Taylor Wimpey (North West)

**PROPOSED ACCESS ARRANGEMENTS
FOX'S BANK LANE, WHISTON**

**STAGE 1/2 - ROAD SAFETY AUDIT
JUNE 2023**

Figure 1: Scope of highways works subject to RSA.

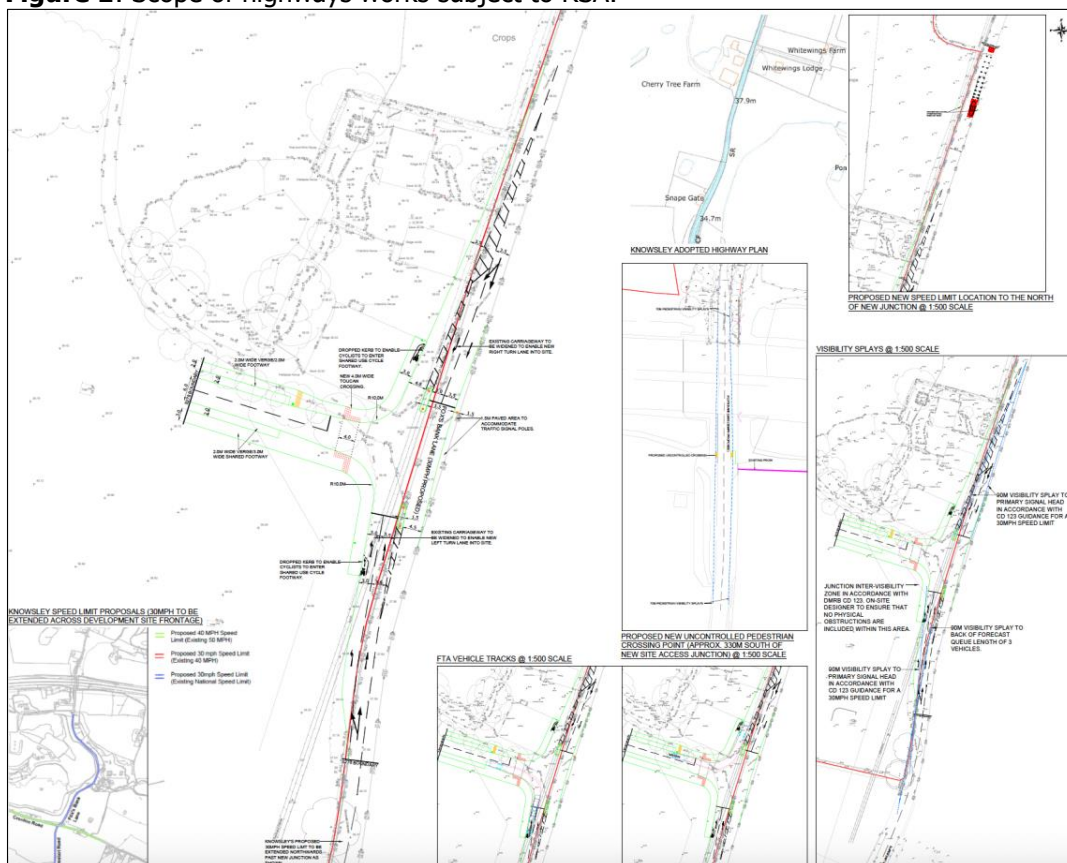
1.10 The scope of the highways works subject to RSA are shown in **Figure 1**.
